DESIGN REVIEW/CERTIFICATE OF APPROPRIATENESS APPLICATION

Re: 6579 Taylor Road Design Review / C of A Comment Response Letter

STAFF REPORT

Applicant is requesting approval of a Design Review application for parking and landscaping alterations at 1641 & 6579 Taylor Road. The property is zoned OCT – Office, Commerce, and Technology district. The site was last approved in April 2021 for the development of approximately 250,000 sq. ft. of twelve different industrial, flex, and storage buildings. Since that approval, the site has been split into two parcels so that the large 144,000 sq. ft. building to the west is on its own 10-acre property (1641 Taylor) and the remainder of the buildings are on another 12.9-acre property (6579 Taylor).

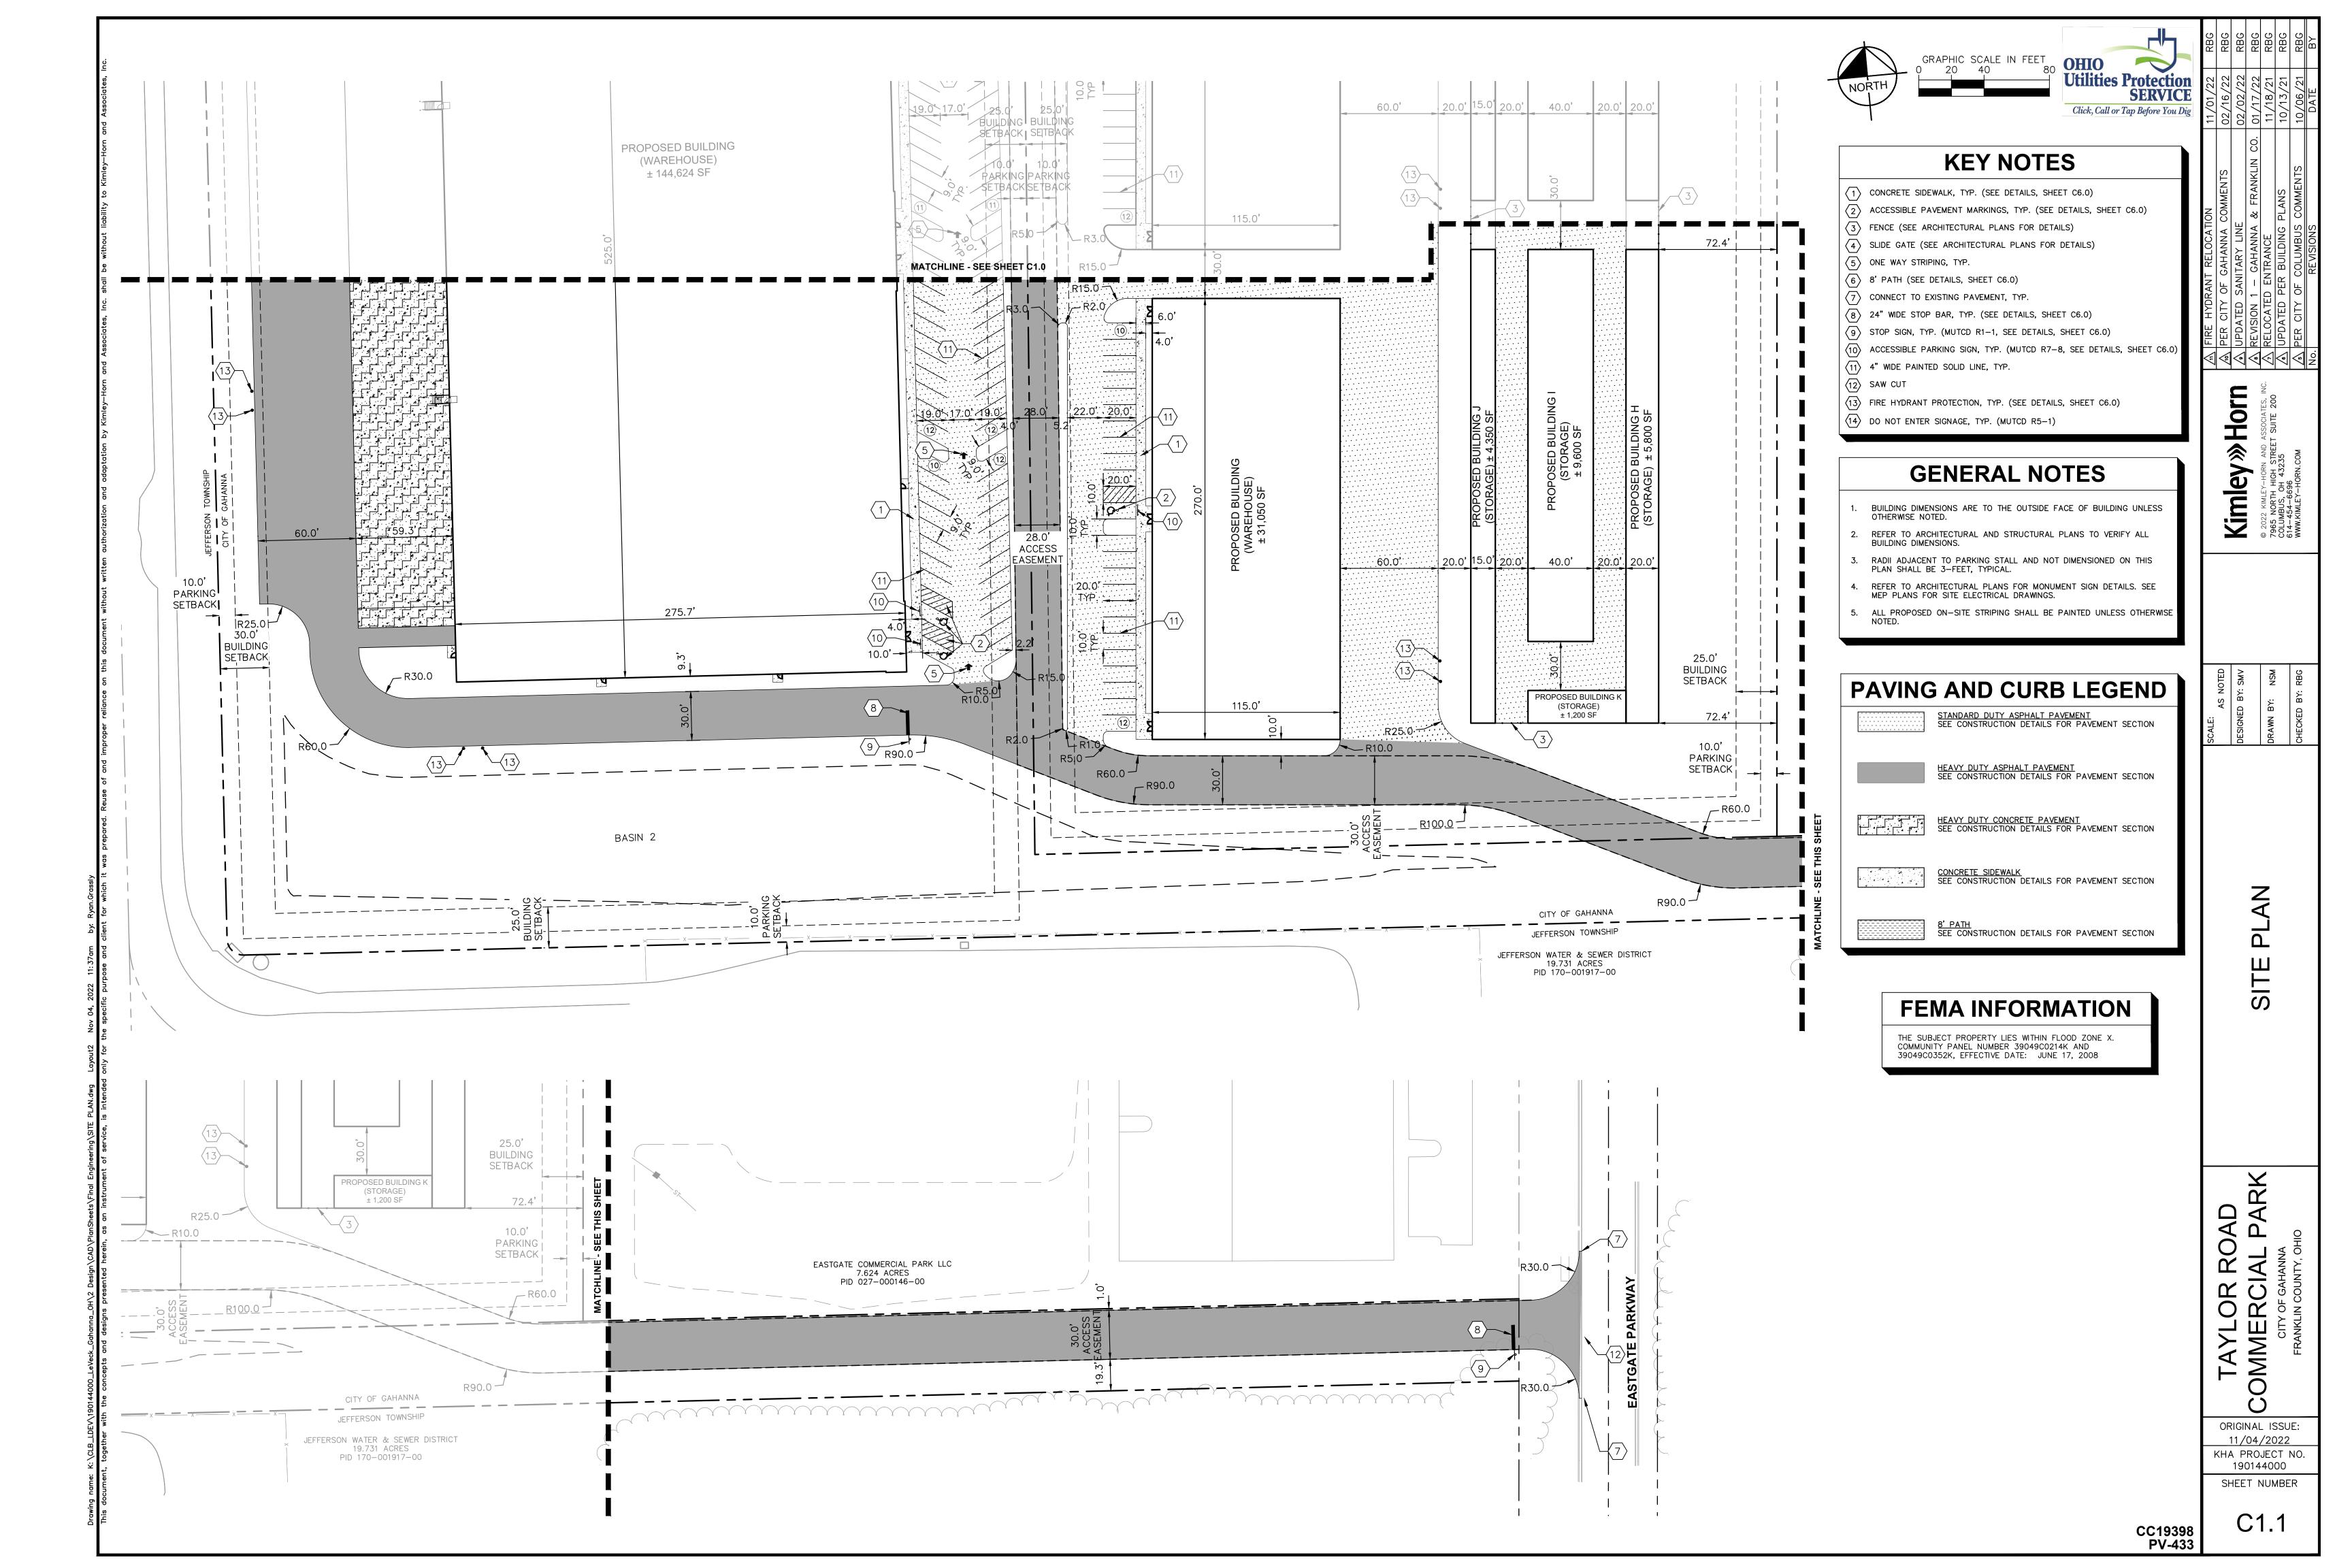
3. Sufficient details are not provided to demonstrate that the "angled" accessible parking spaces will comply with ICC A117.1 Section 502.1. For the angled parking - the access aisle shall be on the passenger side of the parking space as per ICC A117.1 Section 502.4.1. Neither of the angled parking spaces comply with this requirement.

4. With 87 total spaces, 4 are required to be accessible, 1 of which van accessible. Update parking stalls and parking site data.

6. At the south end, the parking stalls get pretty close to the access road; what is the dimension here? Are there parking bumper blocks? Is the area in between the parking stalls and access drive to be landscaped?

7. The ADA spot at the southern end is somewhat questionable with the how the radius return transitions into this spot.

Response: A detail has been added to the plan for the angled ADA parking. The access aisles have also been moved to comply.

Response: 2 additional ADA stalls have been added to the plan. Each of the 4 stalls can be used as van accessible.

Response: The stalls to the south have a 2' separation from the edge of the road. Parking blocks are intended to be used. The area between the parking stalls and access drive is intended to be landscaped.

Response: We have updated the radius of the return in this area to better align with the stalls.

AS1.00

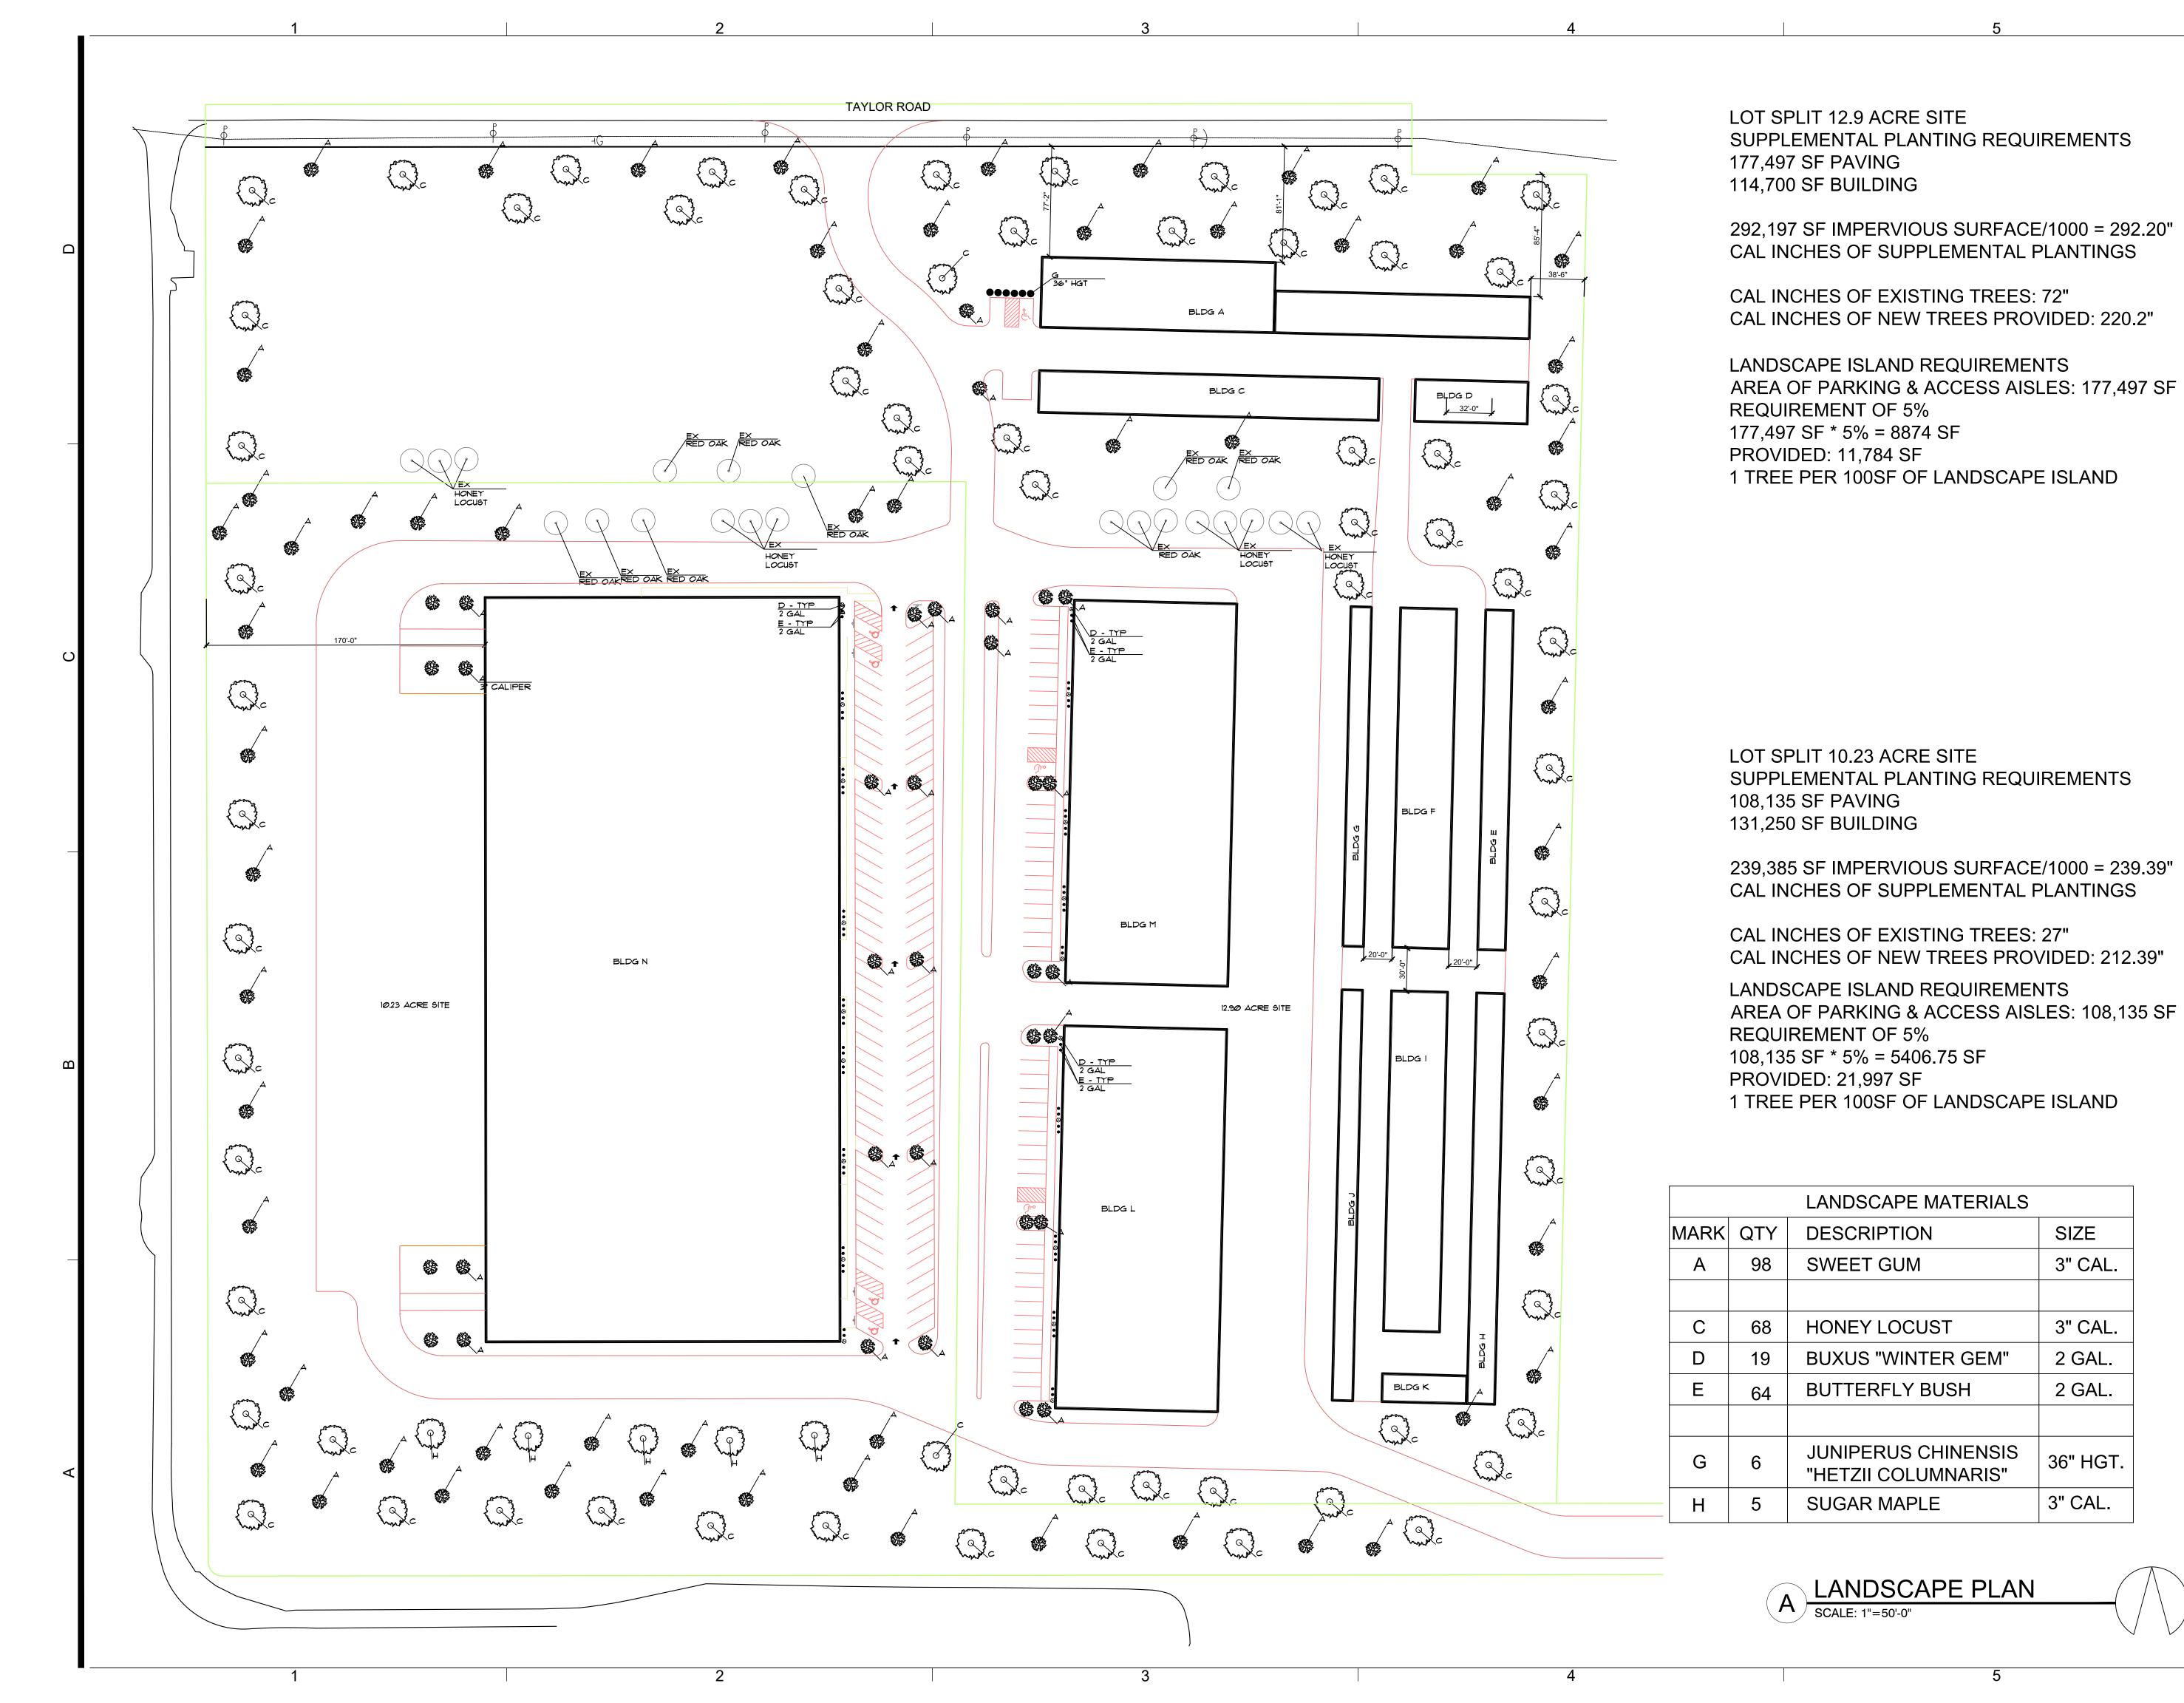
It appears that the landscaped island with parking lot shade trees is being removed. Provide a detailed landscaping plan to show compliance with all of Section 1163.08 for both properties involved. Provide the required landscaping calculations and type of trees, sizes, locations, etc.

2. Landscape plans look mostly appropriate. I would advise against use of butterfly bush since it exhibits many invasive traits

3. The submitted landscaping plan shows the property line splitting the new row of parking spaces, which is not what was approved in the lot split and does not match the property lines shown on the site plan. Please revise to show the correct location of the property line.

4. The landscaping plan shows a different parking configuration next to buildings A & C than what the site plan shows. Please adjust the landscaping plan accordingly and ensure that all features are accurate and true to the proposed site plan.

5. Indicate the number of proposed trees. Only a note is provided for 1 tree per 100sf of required landscaped area

Response: An updated landscape plan has been provided with this submittal.

Response: We've used the butterfly bush on prior projects that have been approved by the city. However, we note that you now have a concern on this variety. We have substituted ninebark in lieu of the butterfly bush.

Response: Location has been revised.

Response: Revised.

Response: Quantities have been added to the landscape plan.
